ST TAMMANY PARISH ADMIN COMPLEX

CONT: NATCO CONST

RFI # 11

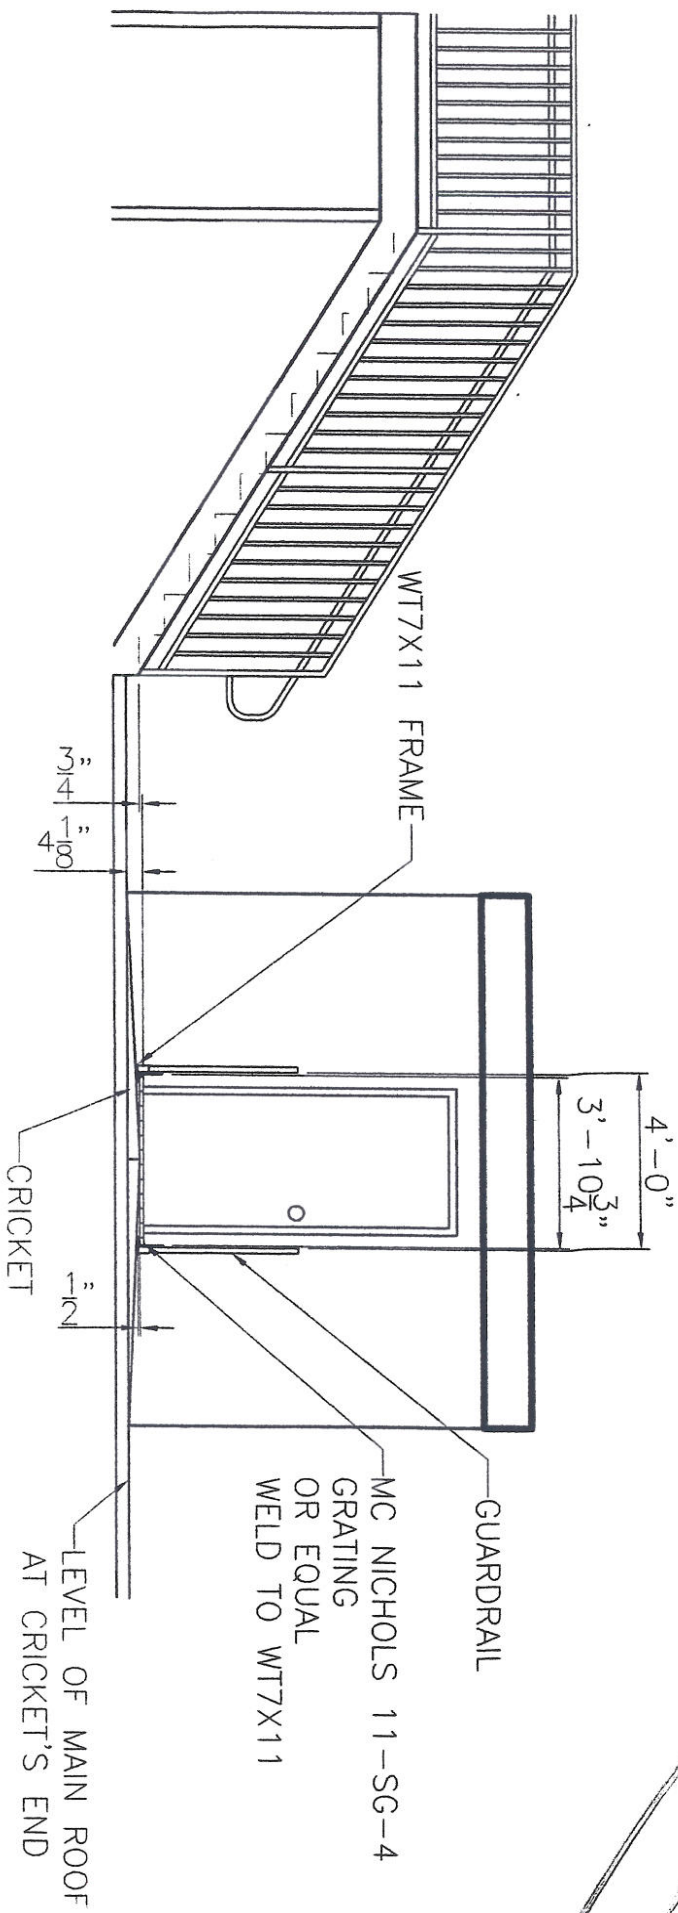
PROPOSED ATTACHMENT NEW W8x35 TO EXISTING W10

approved 11-9-07
 no cost change
 EXISTING CONC
 EXISTING EMBAS

RF1 # 16

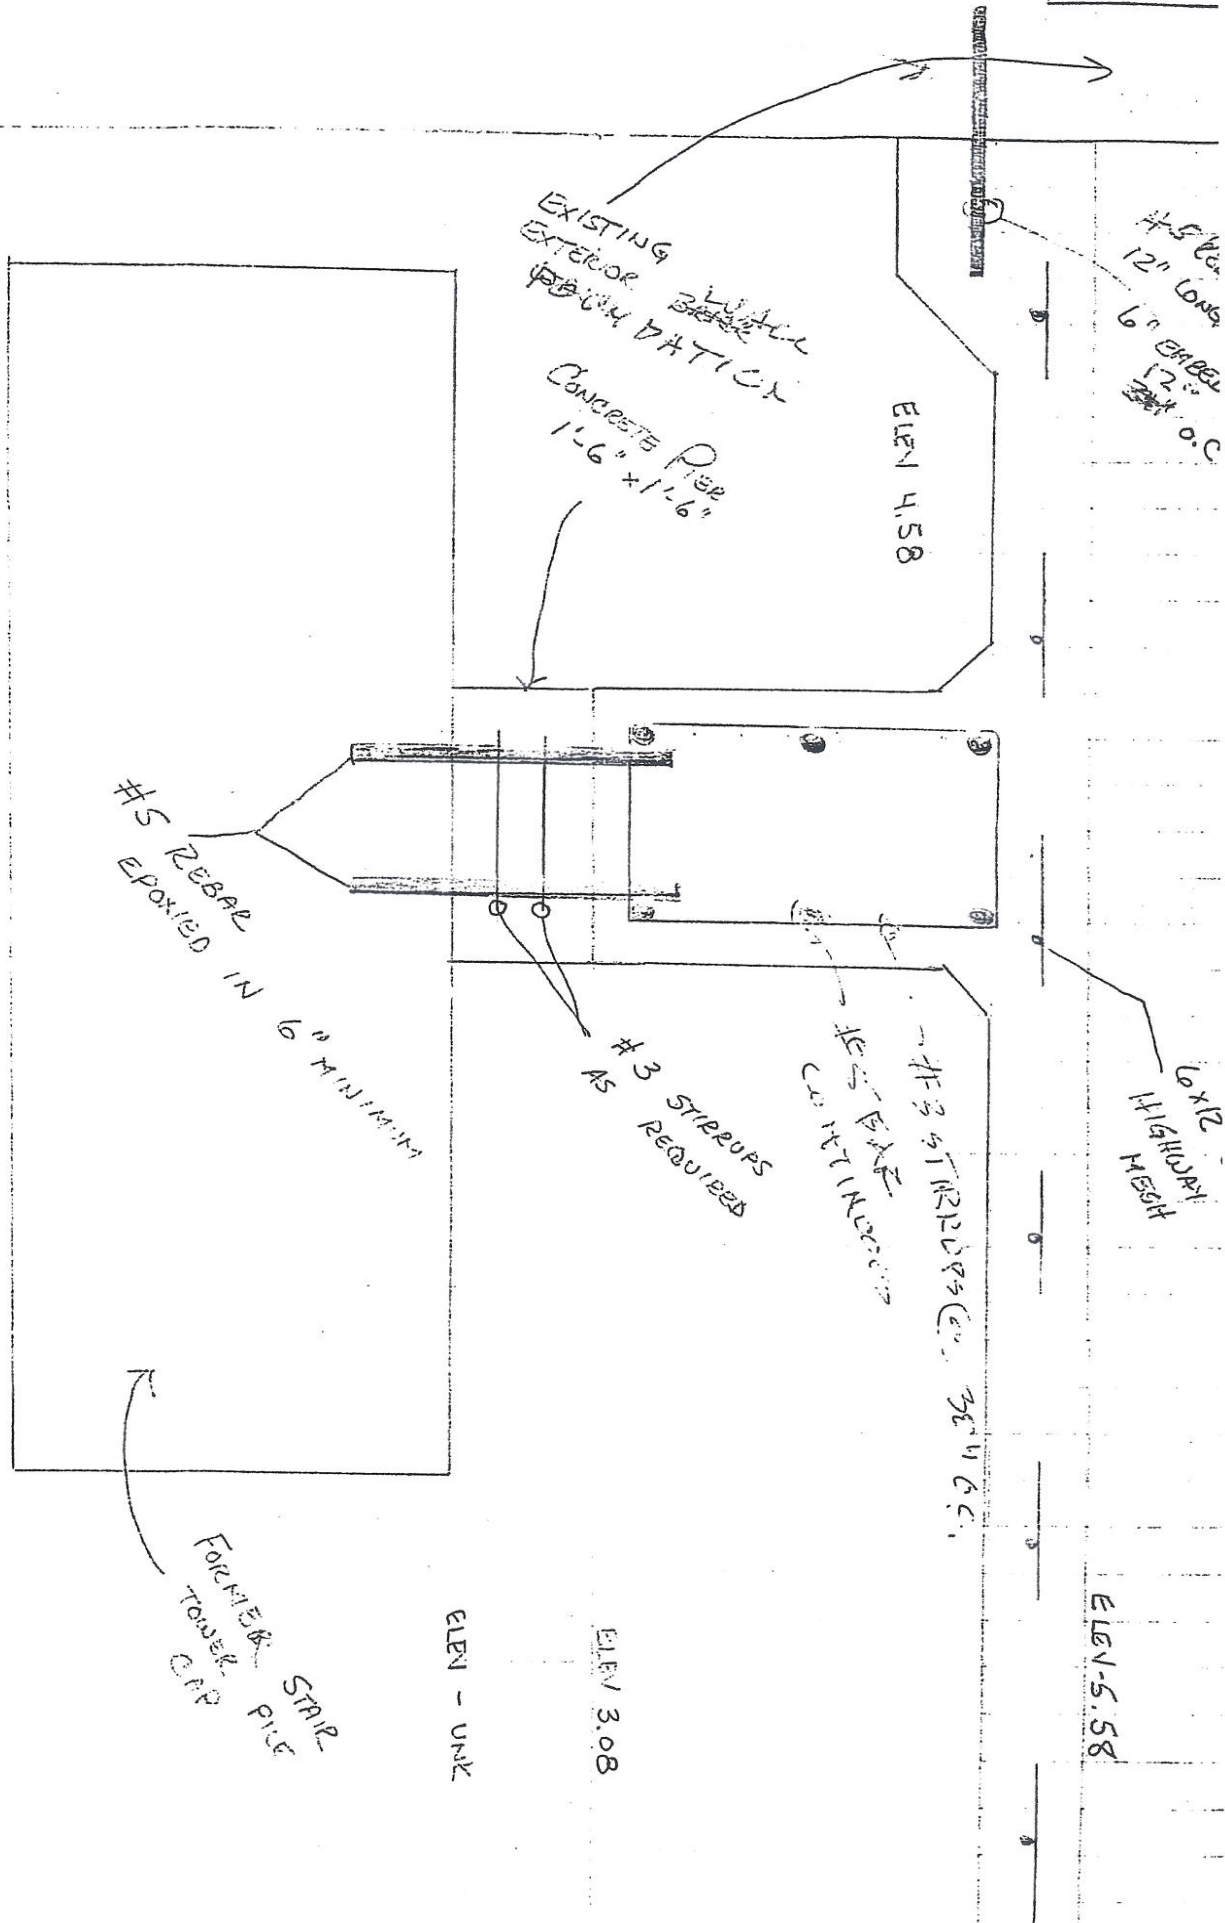
#5 REBAR
12" LONG
6" embed
12" spacing
O.C.

#5 REBAR EPOXIED IN 6" MINIMUM

RF1 #17

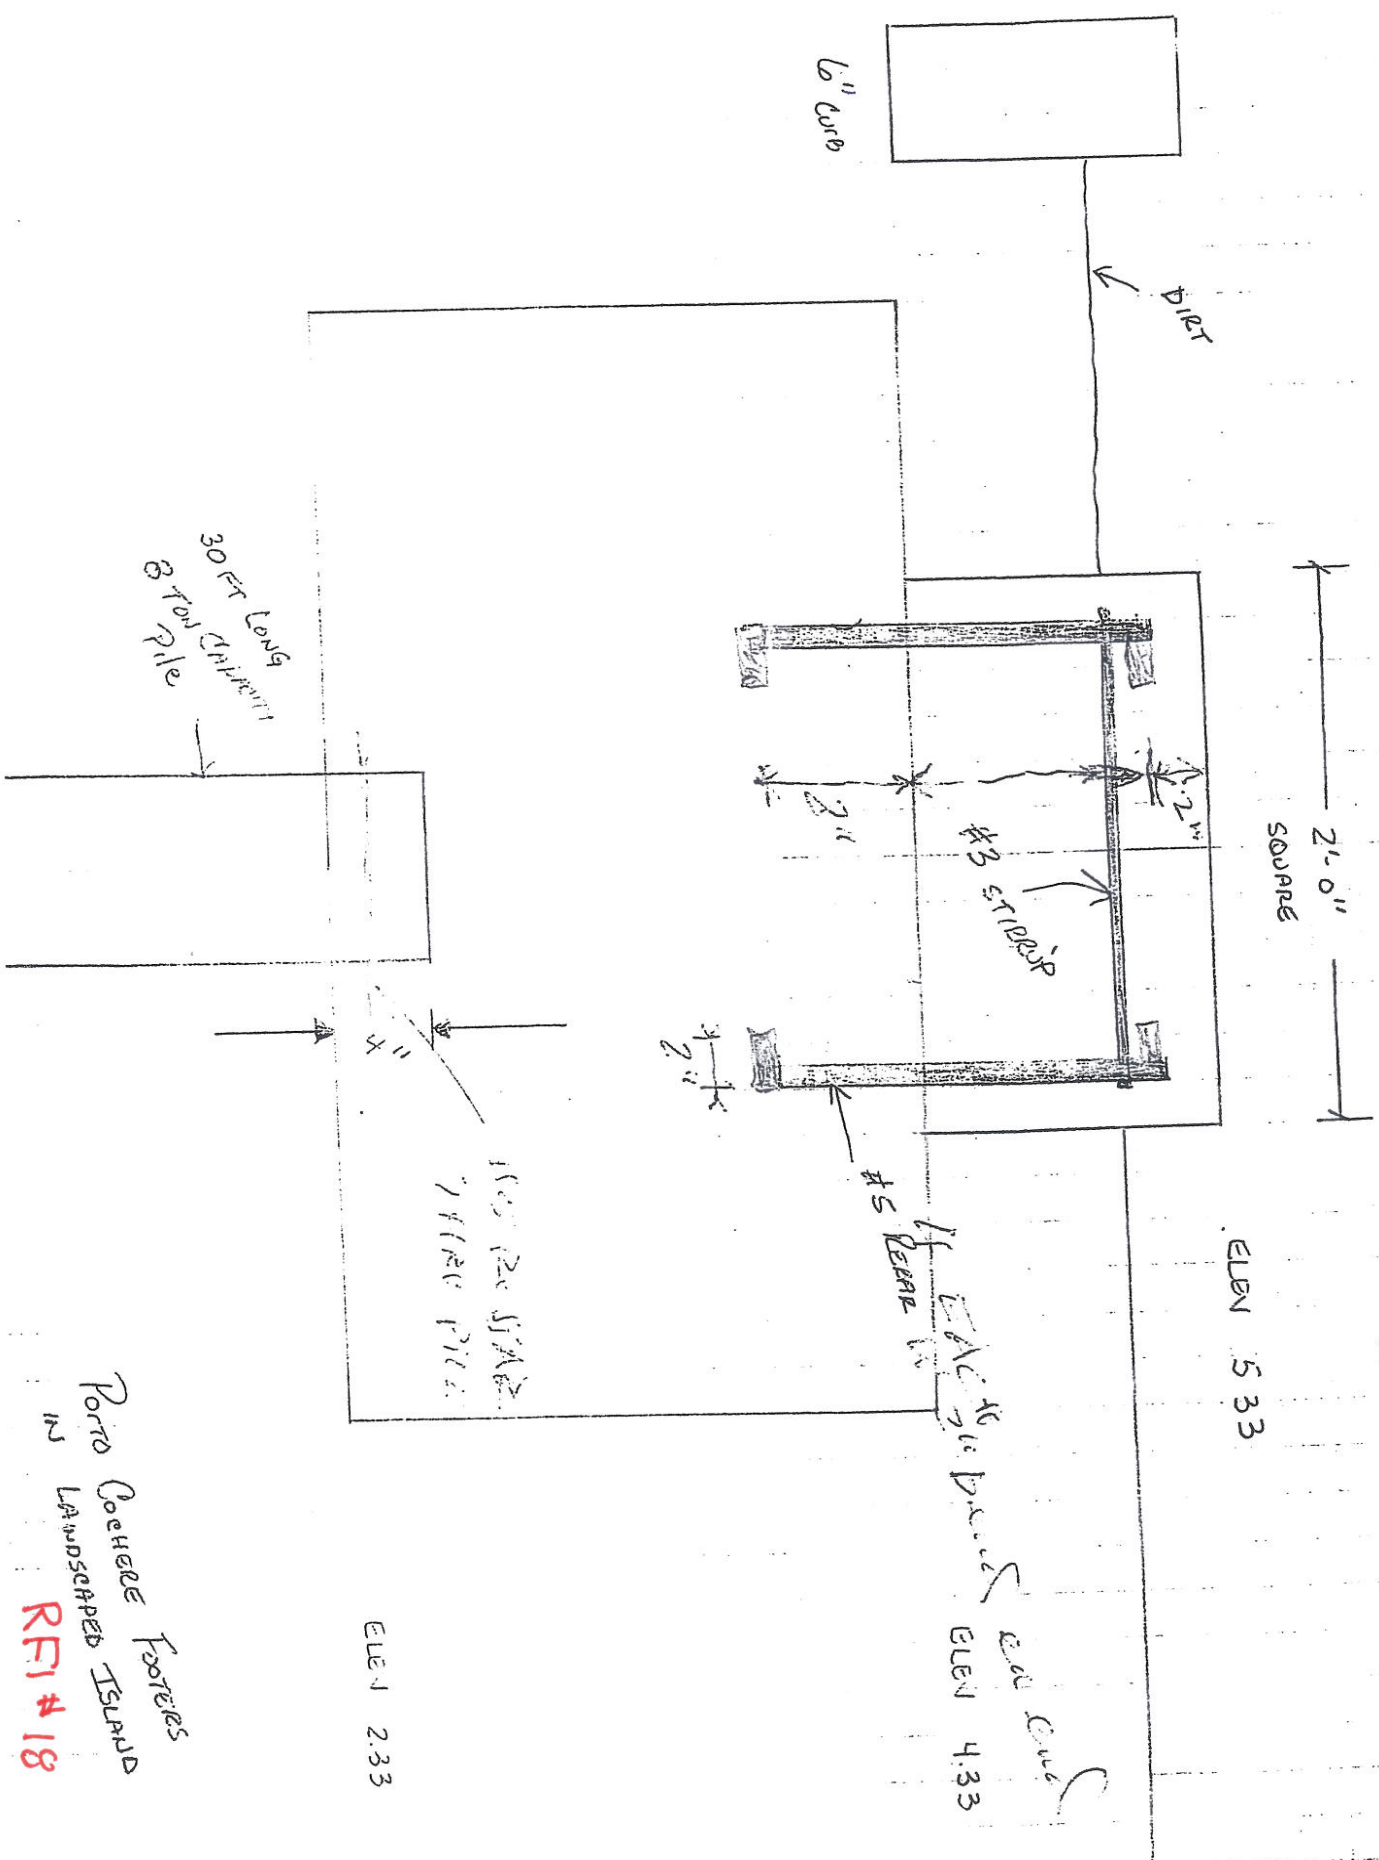
30 FT LONG
8 Ton Capacity
Pile

150# 20 STAIR
TYPICAL PILE

RF1#54

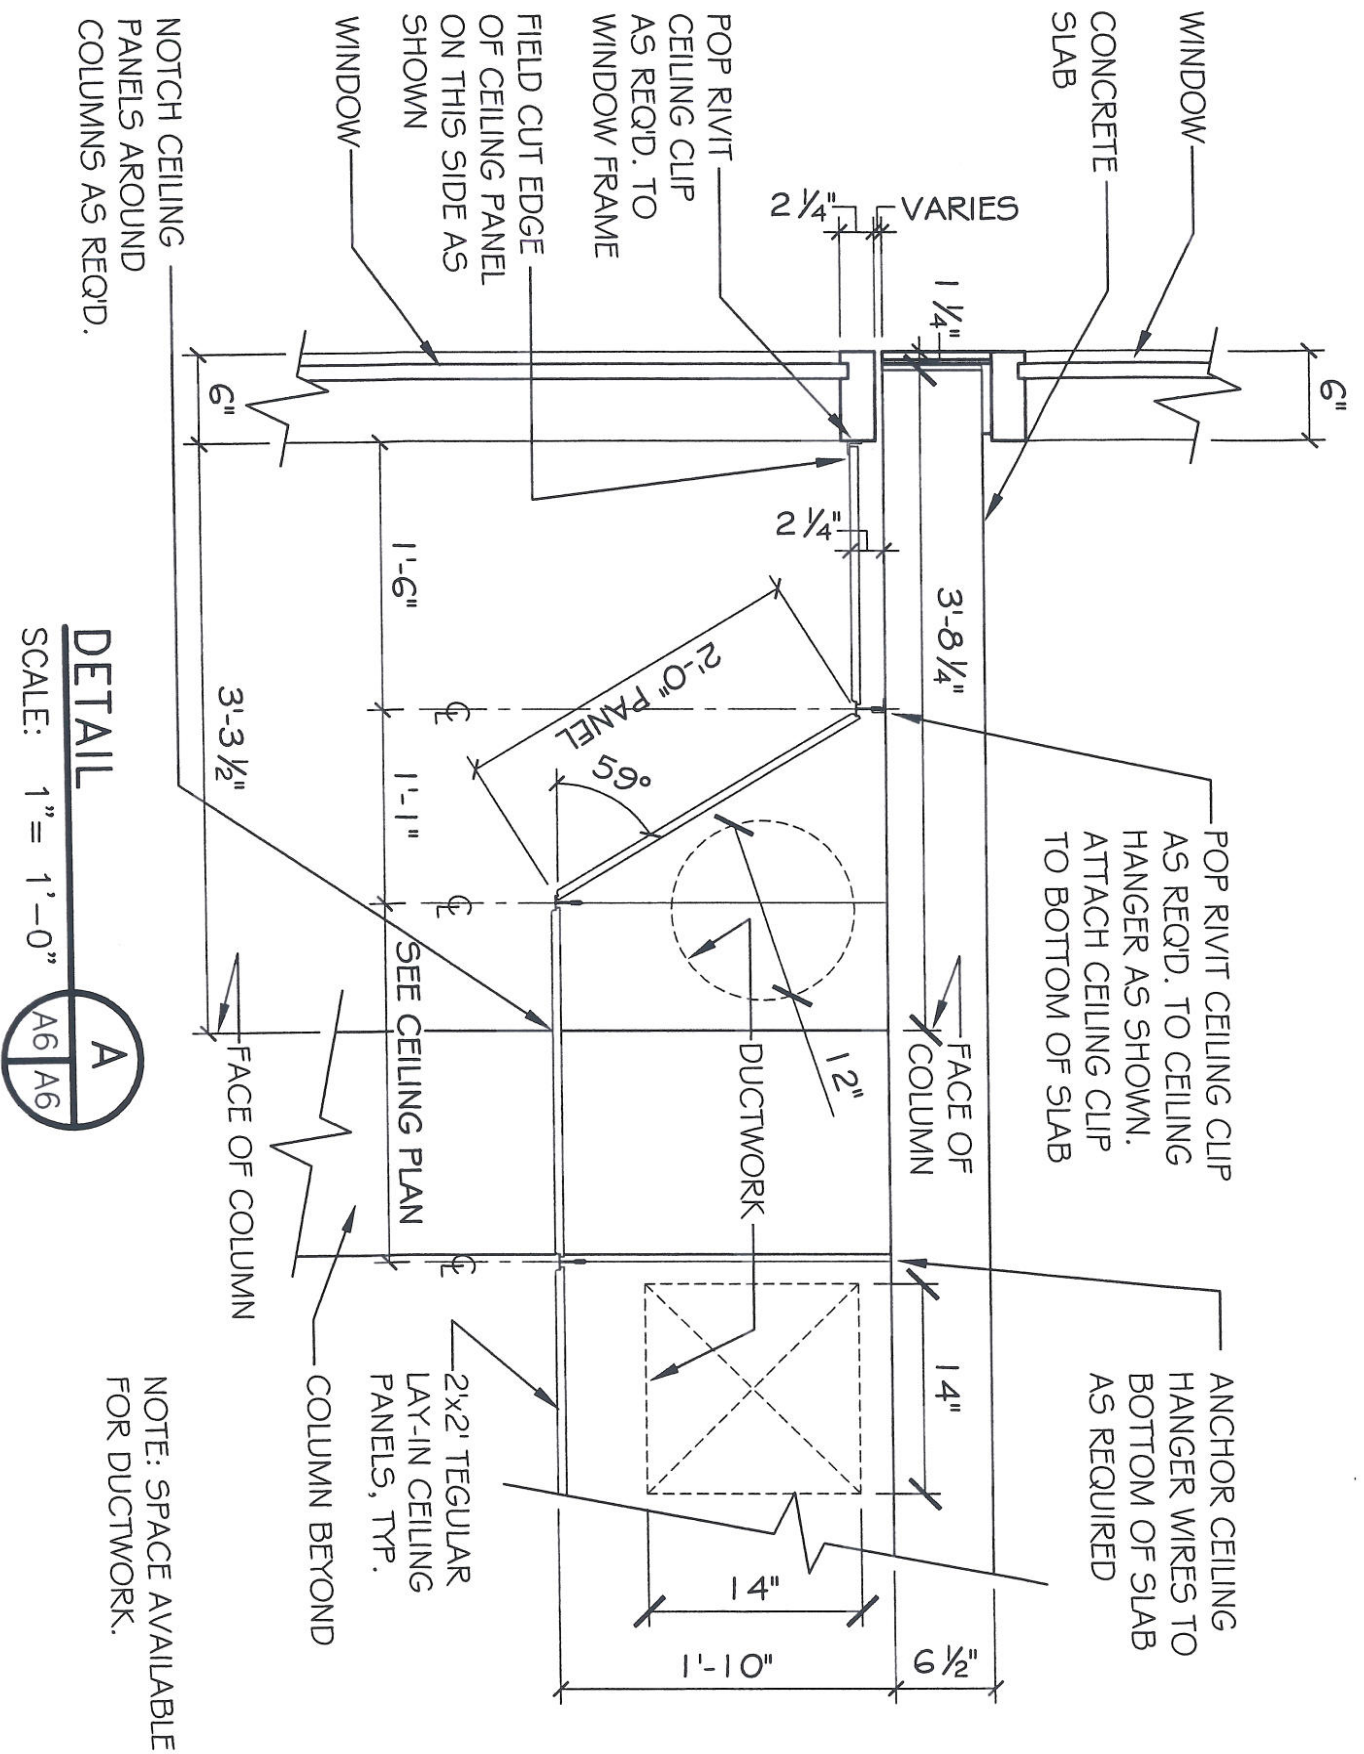
POP RIVIT
CEILING CLIP
AS REQD. TO
WINDOW FRAME

FIELD CUT EDGE
OF CEILING PANEL
ON THIS SIDE AS
SHOWN

NOTCH CEILING
PANELS AROUND
COLUMNS AS REQD.

POP RIVIT CEILING CLIP
AS REQD. TO CEILING
HANGER AS SHOWN.
ATTACH CEILING CLIP
TO BOTTOM OF SLAB

ANCHOR CEILING
HANGER WIRES TO
BOTTOM OF SLAB
AS REQUIRED

RF 1 # 53

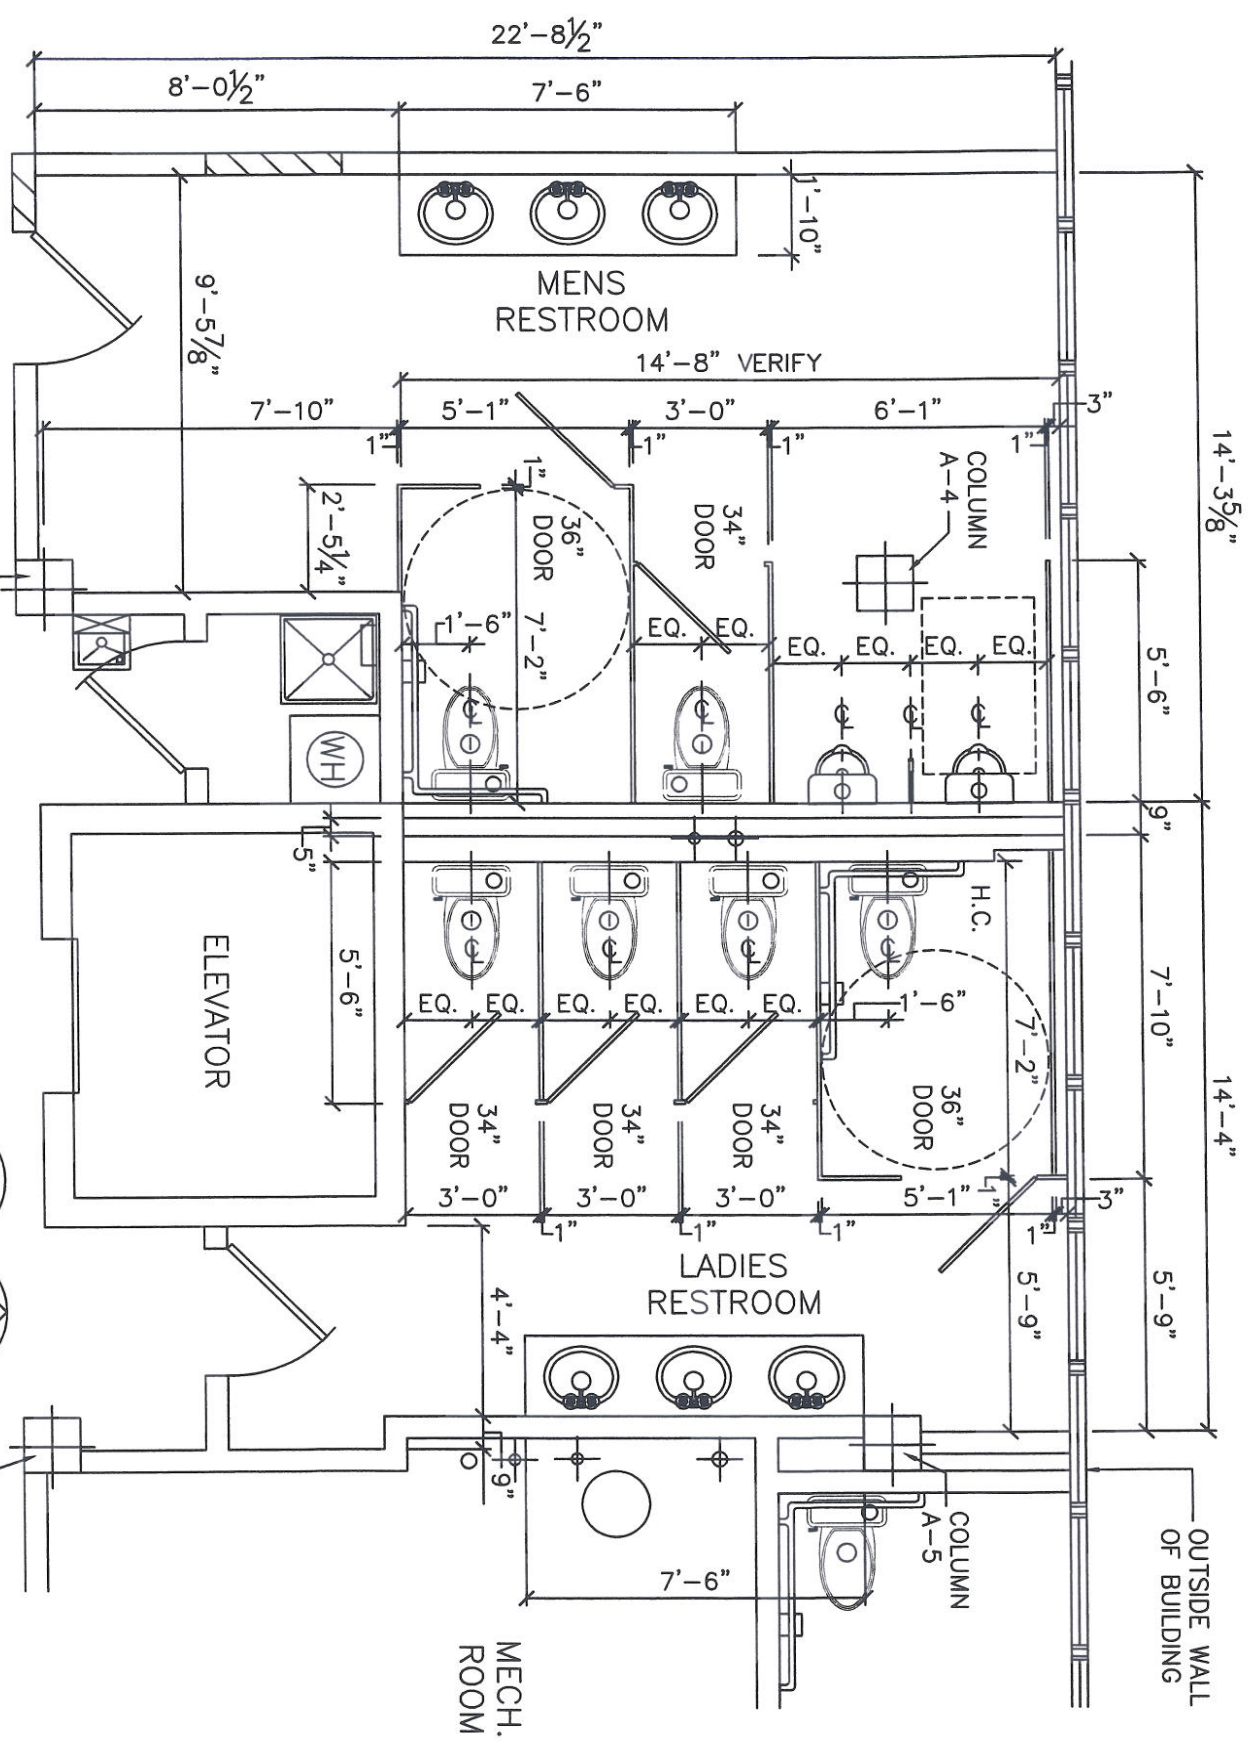
NOTE: SPACE AVAILABLE
FOR DUCTWORK.
